Proposal for Amendment 1 (Phase 2 of the global technical Regulation)

ECE/TRANS/WP.29/GRSP/2018/27

Submitted by the Informal Working Group on the Phase 2 of UN Global Technical Regulation No. 7*

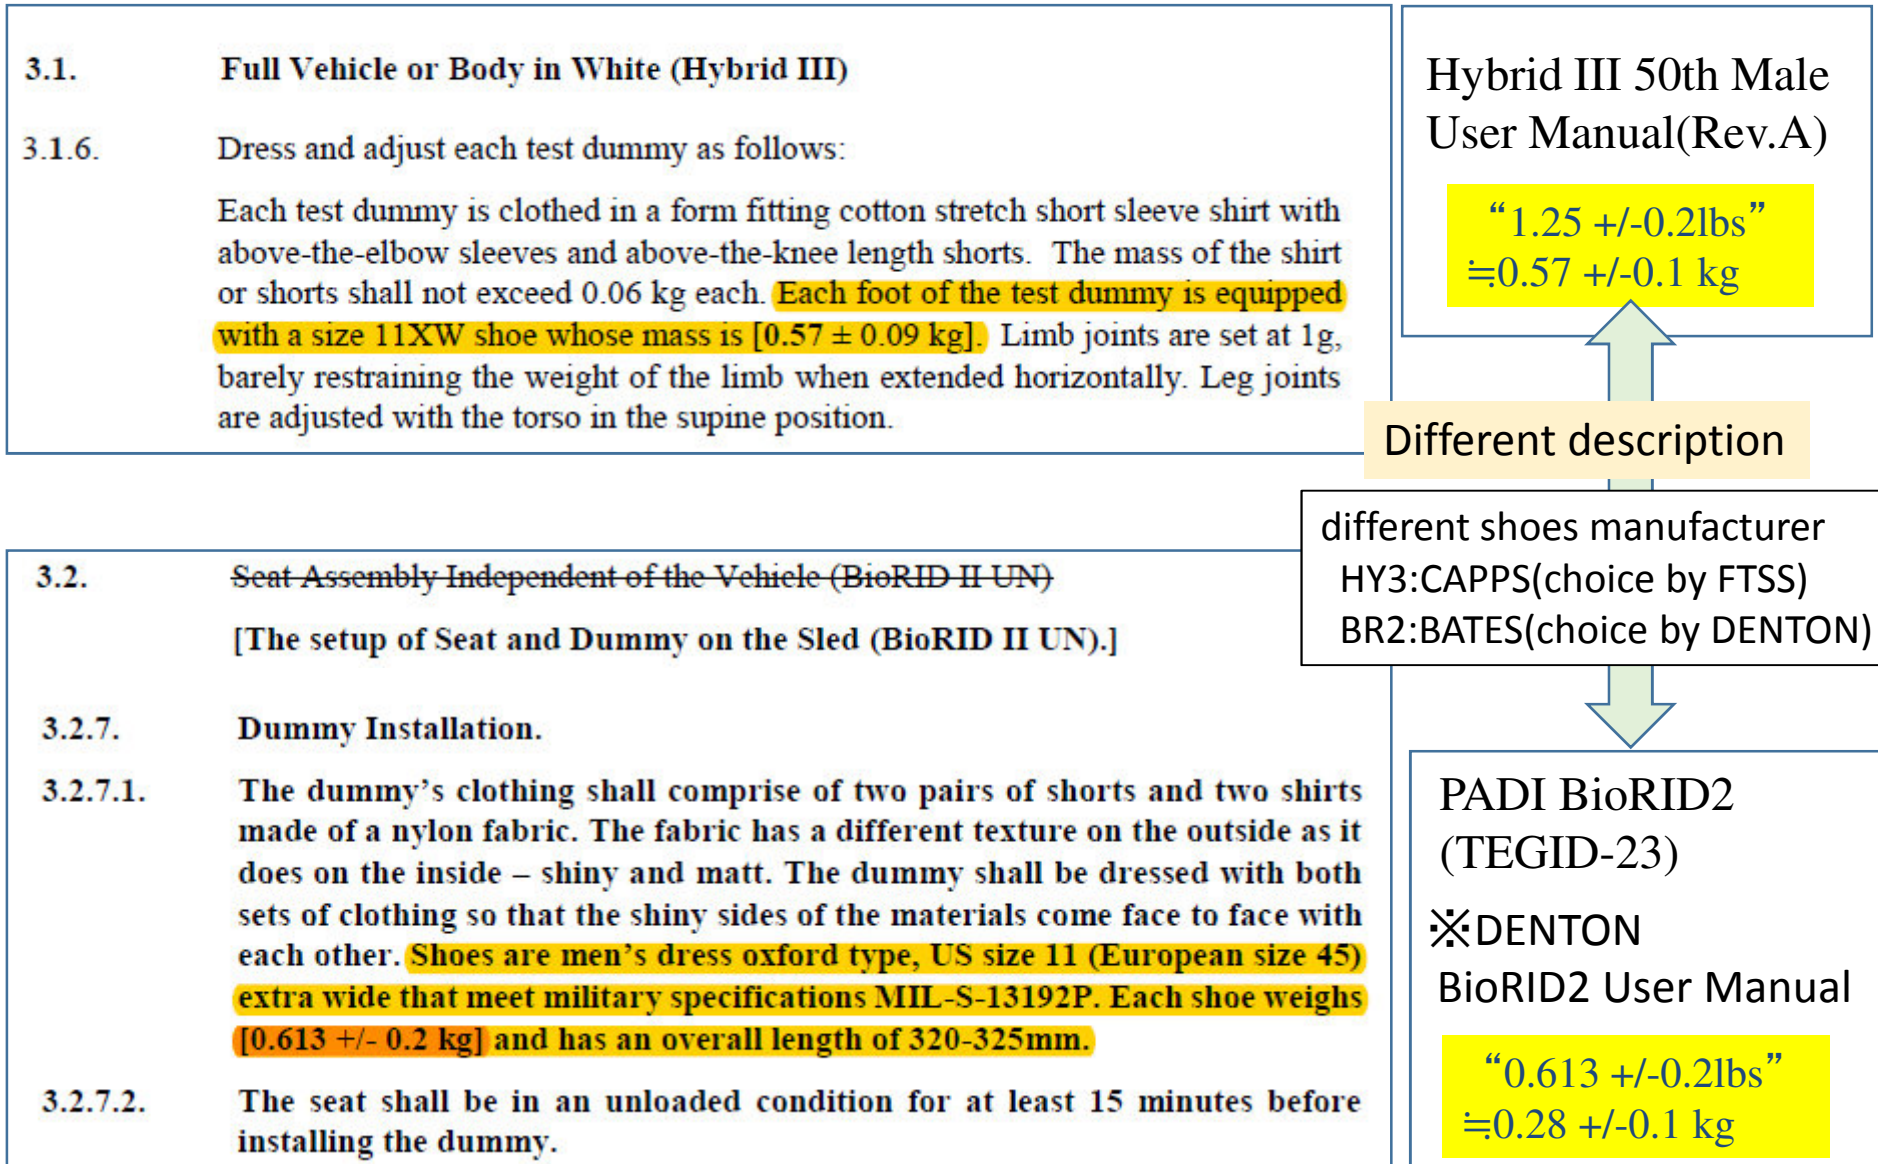
“1.25 +/-0.2lbs \cong 0.57 +/-0.1 kg

“0.613 +/-0.2lbs \cong 0.28 +/-0.1 kg

“0.613 +/-0.2lbs ≅ 0.28 +/-0.1 kg
